PLANNING AND ZONING COMMISSION MEETING

City Council Chambers, 33 East Broadway Avenue Meridian, Idaho
Thursday, May 05, 2022 at 6:00 PM

STAFF REPORT COMMUNITY DEVELOPMENT DEPARTMENT

STAFF REPORT

EXHIBIT MAP

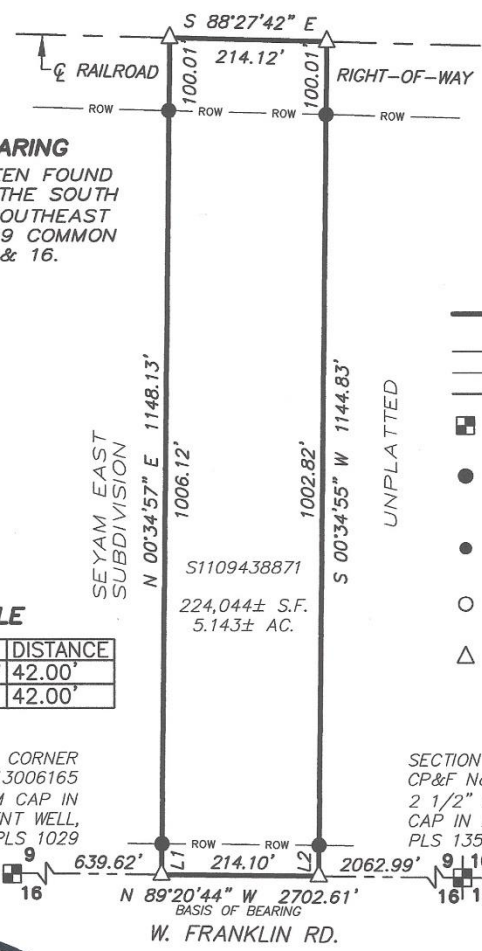
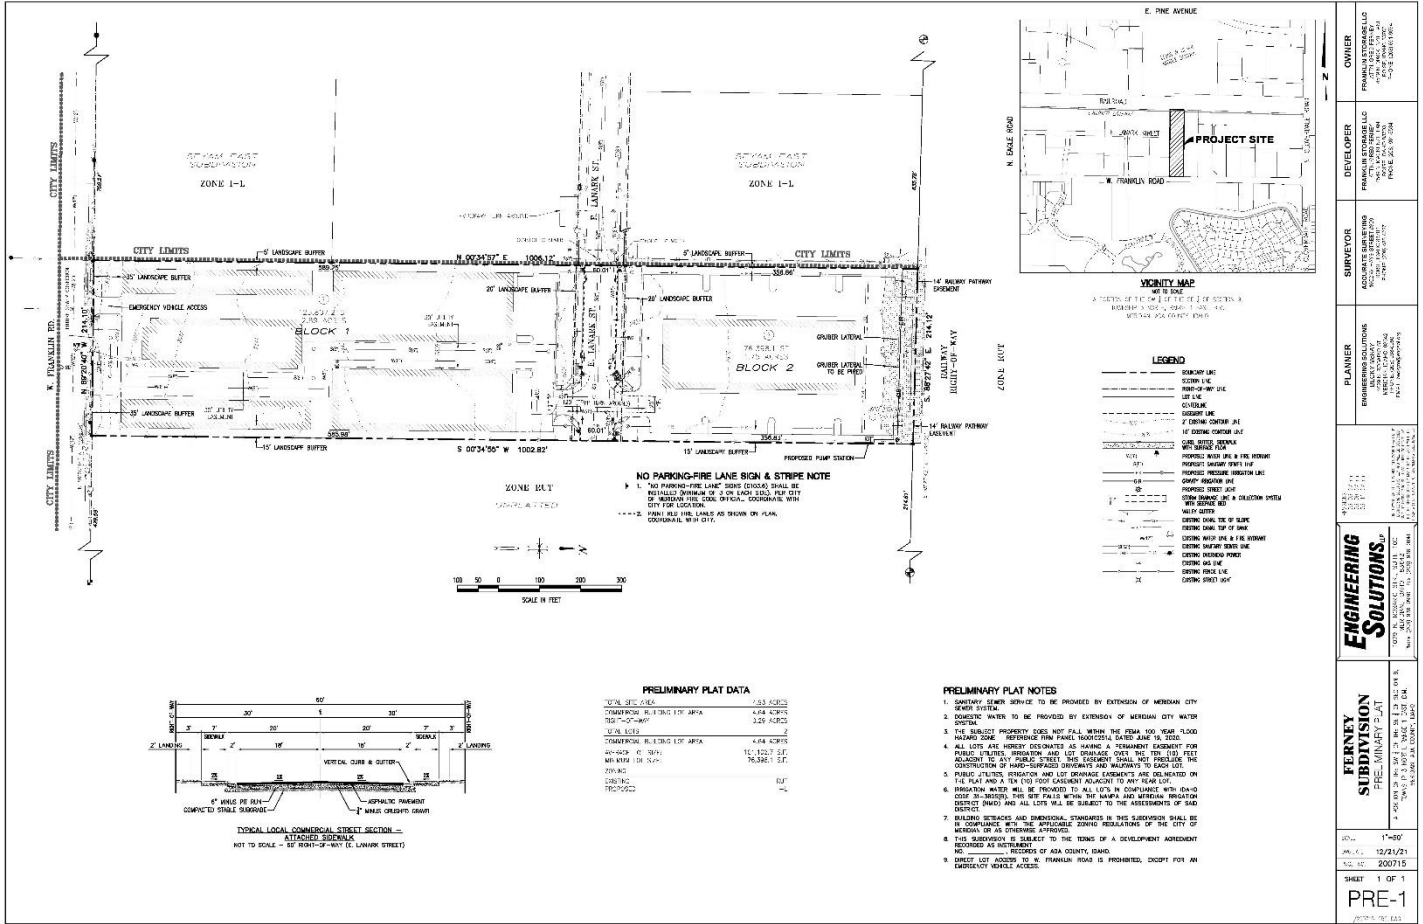
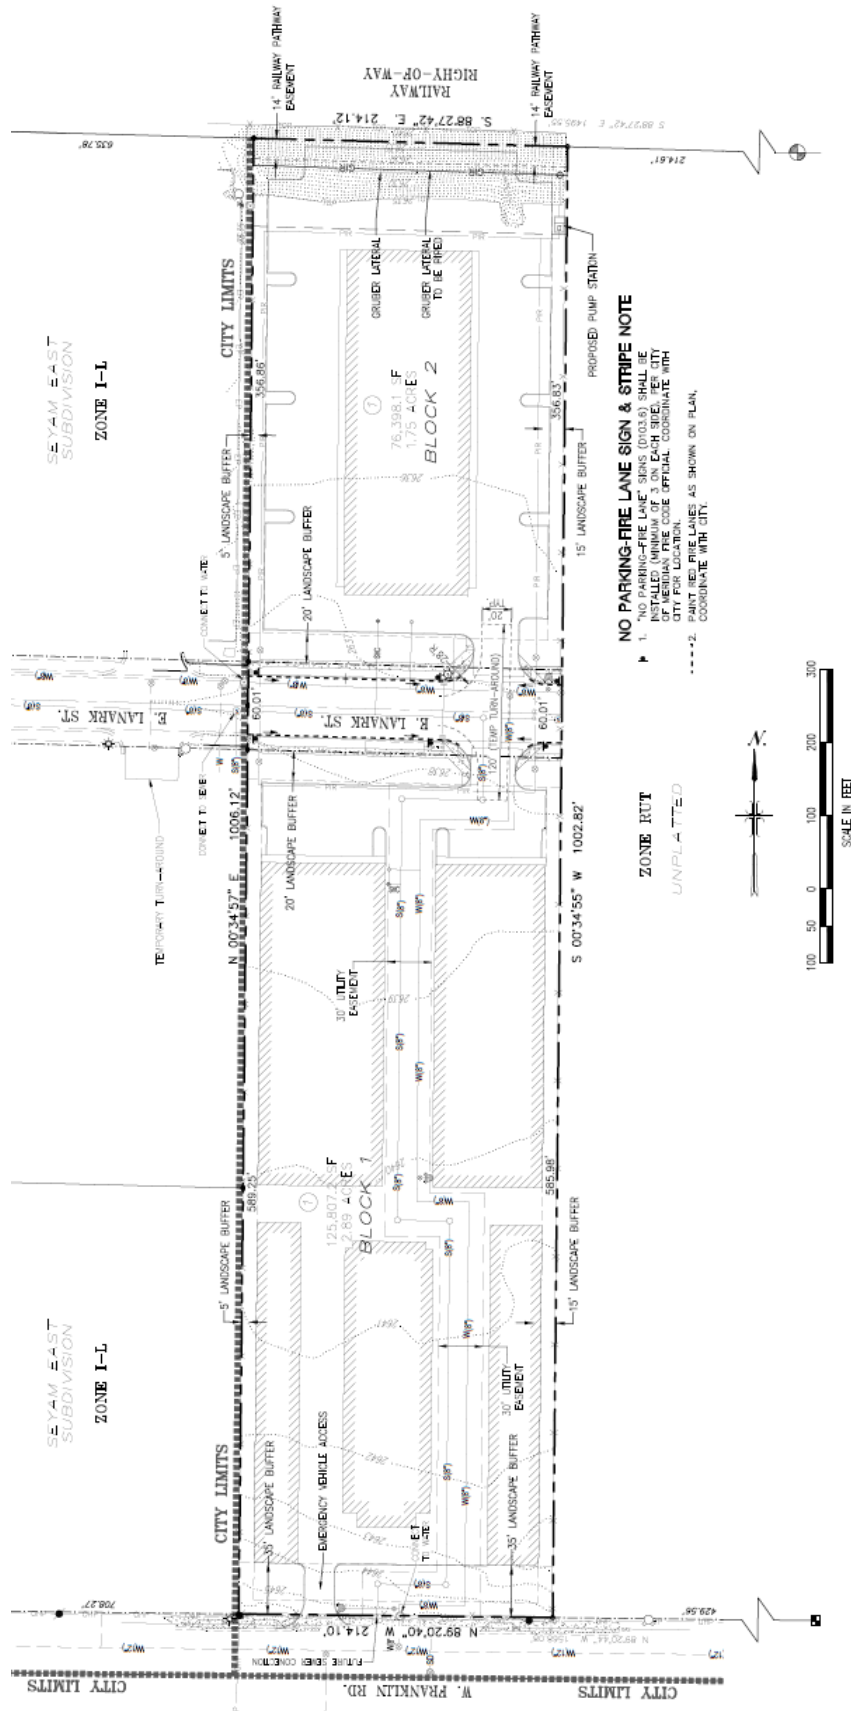
With previous applications north of the subject site, Applicants did not annex to the centerline of the railroad right-of-way which was a mistake and the City did not catch it. In light of this, Staff is asking the Applicant to revise their annexation and zoning request to include the full railroad right-of-way instead of just to the centerline. Staff has included this comment within the conditions of approval.

Please submit a revised annexation legal description and exhibit map 15 days prior to the City Council hearing that includes the full width of the railroad right-of-way north of the subject site.

LANDSCAPE PLAN

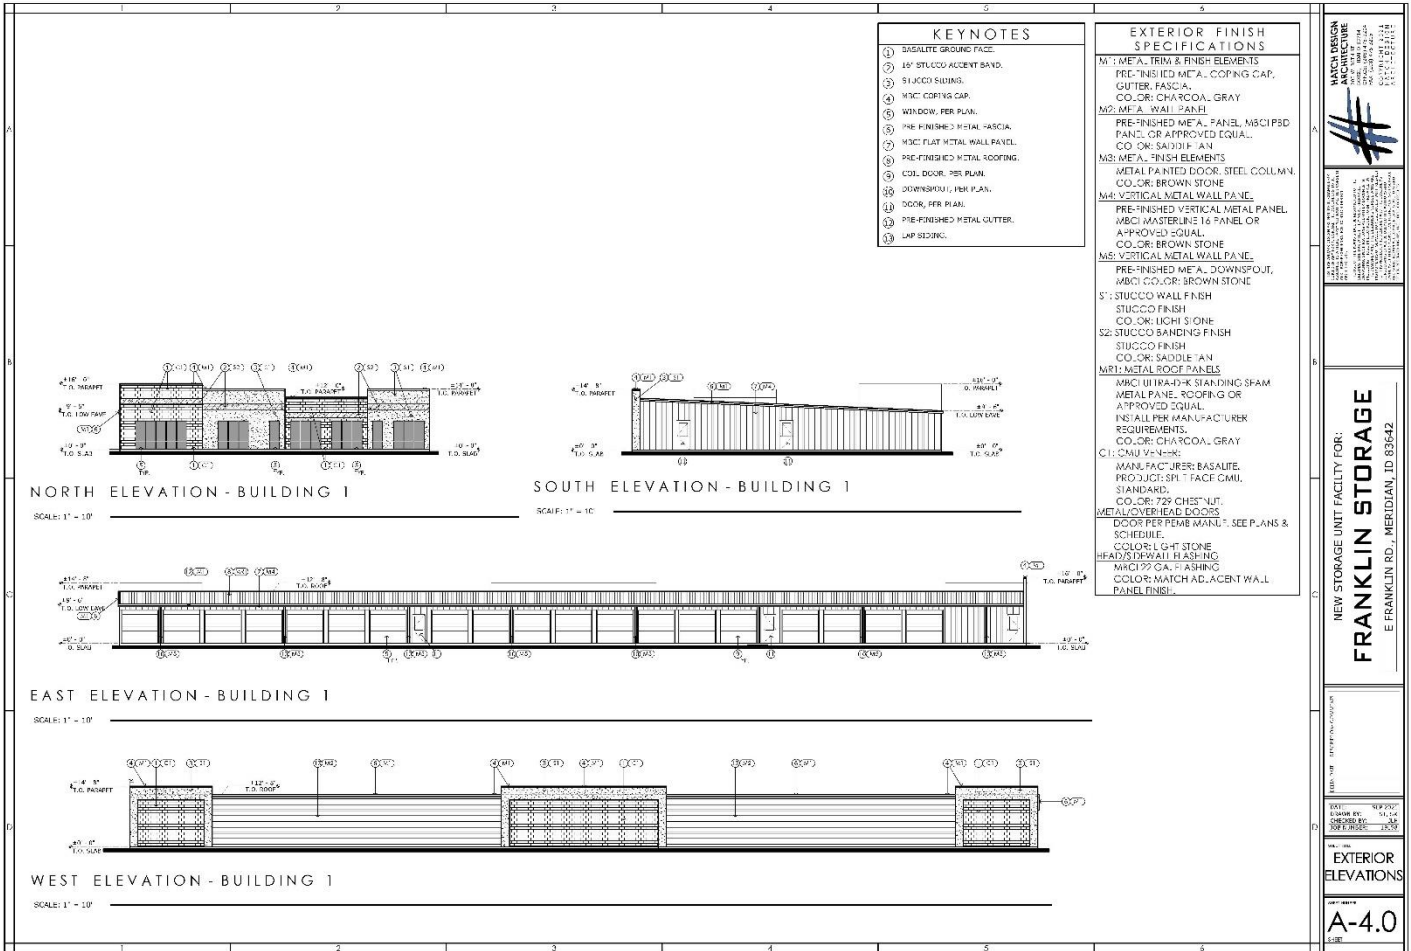
Staff has concerns with the parkways strips not being included within the landscape buffer easements along Lanark and the lack of any vegetation shown within these parkways on the submitted landscape plans. Staff recommends the landscape buffer easement be extended to the back of curb to comply with the UDC and to revise the landscape plans to show additional grasses within the parkway strip. Further, the landscape buffers along Lanark do not show the required vegetative ground cover, similar to the Franklin buffer. Therefore, Staff is also including

a condition of approval to add additional vegetative ground cover beyond grass to comply with UDC 11-3B-7C.3.

No fencing is shown on the submitted landscape plan but fencing is required per the specific use standards for the proposed self-service storage facility use adjacent to the existing residential use to the east. Staff is including a condition of approval to include code compliant fencing along the entire east property boundary.

Because this area of the plat is adjacent to a vehicular use area around the Flex building, parking lot landscaping is required per UDC 11-3B-8 and should include trees and other vegetative ground cover. The submitted landscape plans do not depict any trees within this area as the irrigation easement does not allow trees. Further, the Applicant will need to obtain a license agreement with the irrigation district in order to construct what is shown on the landscape plans. Staff does not find what is proposed on the landscape plans to comply with the minimum code requirements discussed. The Applicant should submit for Alternative Compliance with the future final plat to propose an equal or superior means of complying the landscaping outlined in UDC 11-3B-8 within or adjacent to the Evans Drain easement.

- c. Include additional trees and show they will touch at maturity along the east property boundary for a minimum of the first 185 feet measured from the back of the existing sidewalk for additional screening.

- d. Depict the proposed type of fencing on a sheet within the landscape plans to ensure compliance with UDC 11-3A-7 and the applicable specific use standards. Chainlink fencing with or without slats does not qualify as a screening material in accord with UDC 11-3B-5M.

B. Combined Preliminary/Final Plat (stamp date: January 12, 2022)

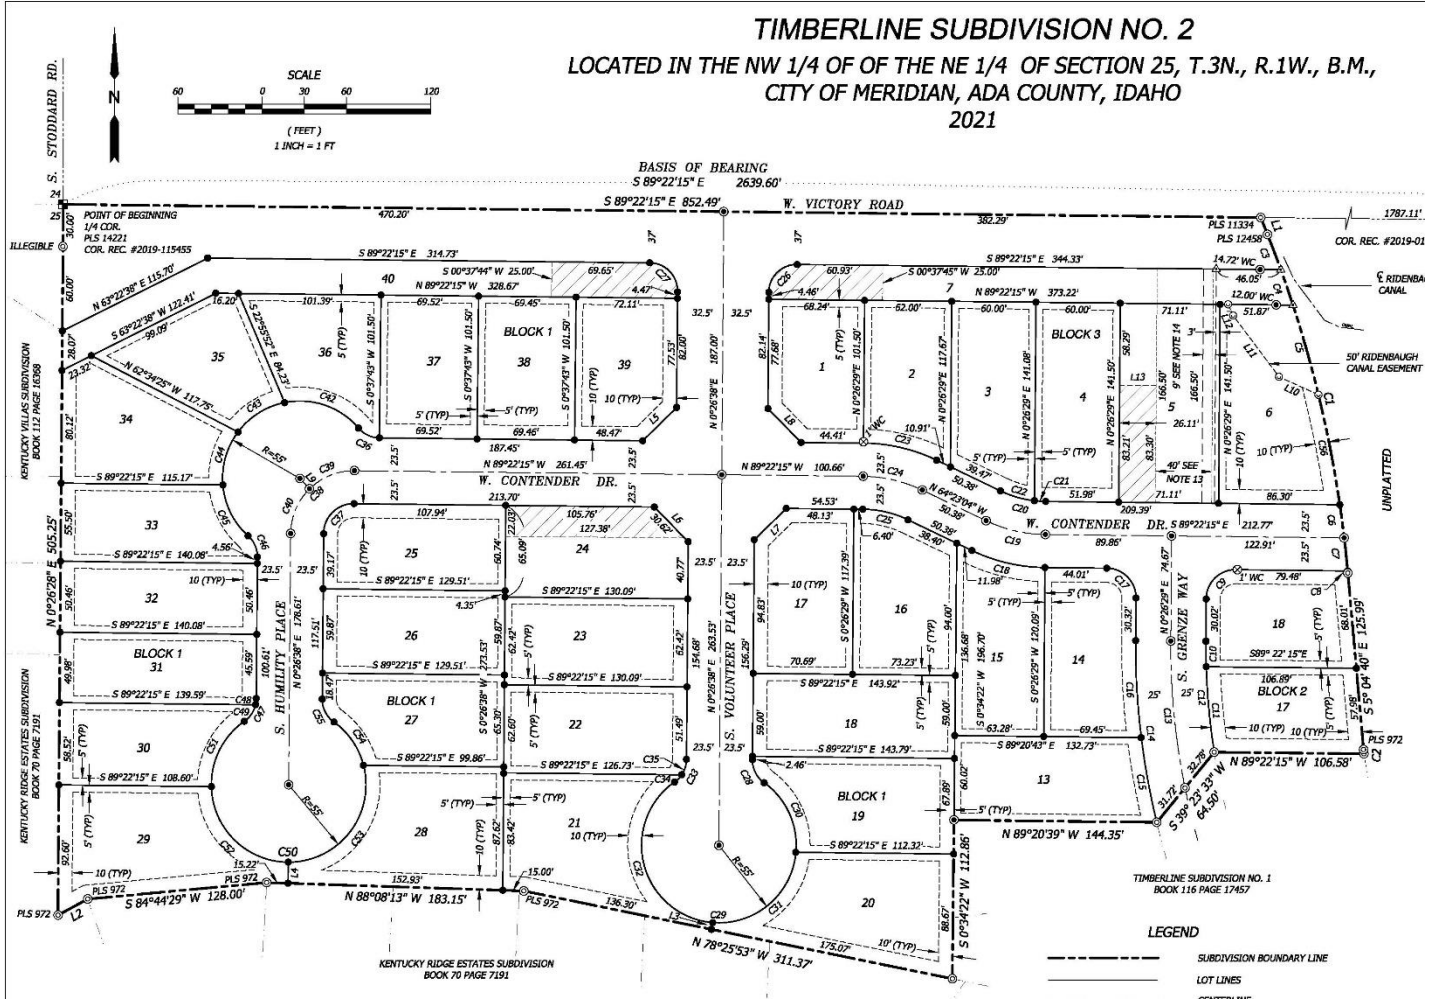
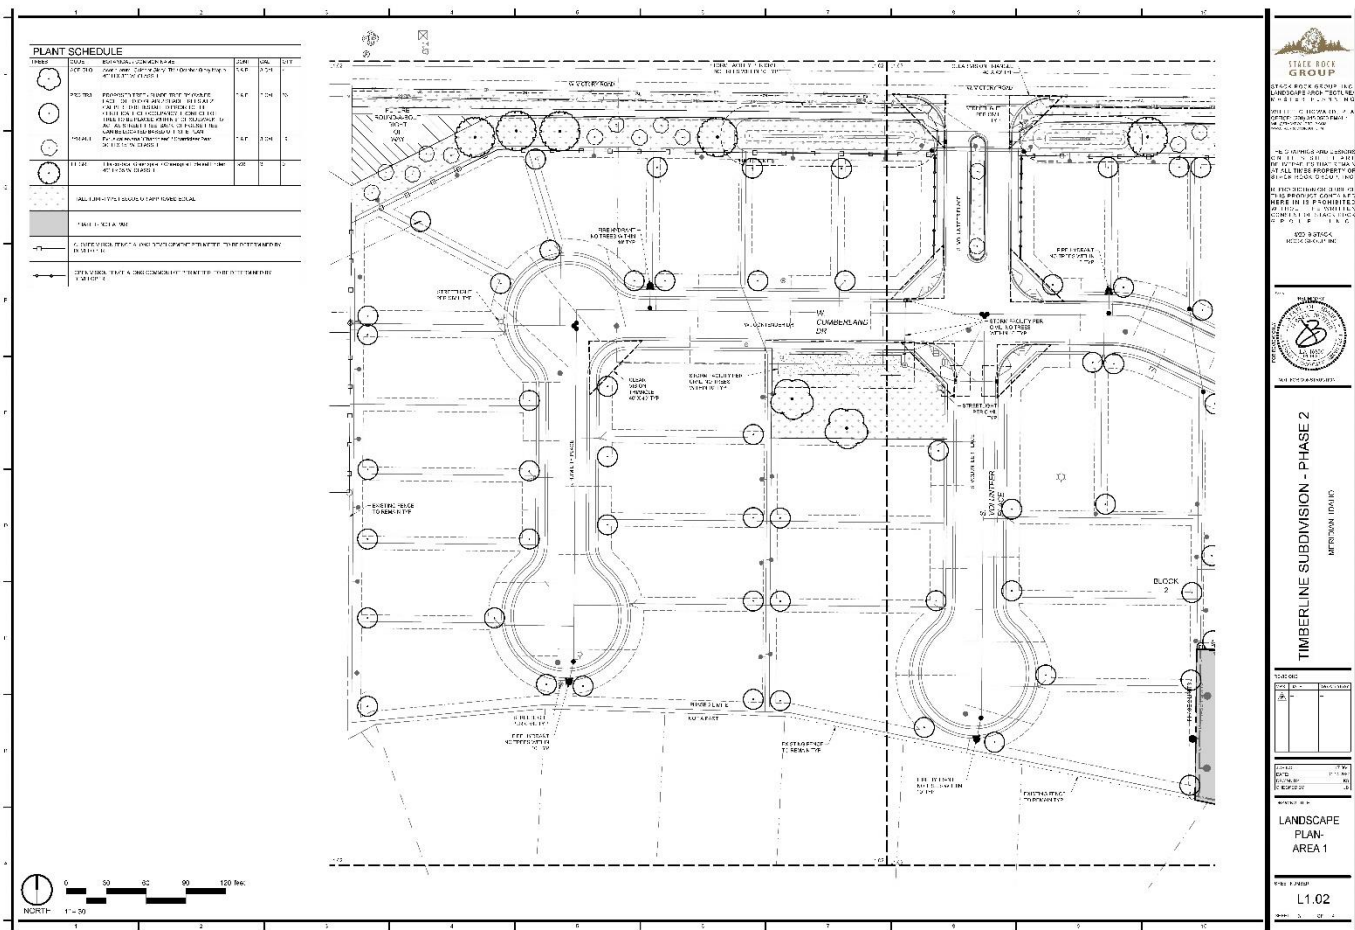
3. The final plat prepared by Sawtooth Land Surveying, LLC, with a stamped date of January 12, 2022, shall be revised as follows at the time of Final Plat Signature submittal:

- a. Note #5 shall be corrected to show read "...Title 11 of Meridian City Code..." instead of "Title II..."
 - b. Note #14 – add applicable instrument number.

- c. Add ACHD R/W Instrument number on final plat where ultimate right-of-way is shown.
4. The submitted landscape plan prepared by Stack Rock Group, dated 01/14/2020 shall be revised as follows at the time of Final Plat Signature submittal:
